HYUNDAI Technical Service Bulletin

NUMBER
20-BE-002H

MODEL(S)
PALISADE (LX2)

SUBJECT: BLIND-SPOT COLLISION WARNING (BCW) RADAR UPDATE

BCW Malfunction Indicator Message

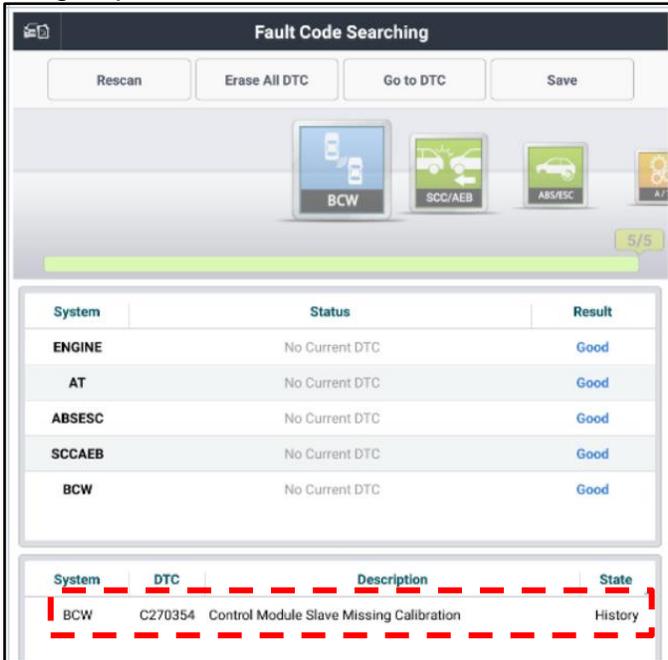
Description: Some Palisade (LX2) vehicles may intermittently experience the BCW Malfunction Indicator Light ON with a message “Check Blind-Spot Collision Warning System” displayed on the instrument cluster. When the BCW Malfunction Indicator Light is ON, the BCW function becomes inoperative. This bulletin provides the service procedure to update the BCW system software to correct the intermittent BCW Malfunction Indicator Light.

NOTE: When the BCW Malfunction Indicator Message turns ON, the diagnostic code C270354 (Control Module Slave Calibration) will be triggered.
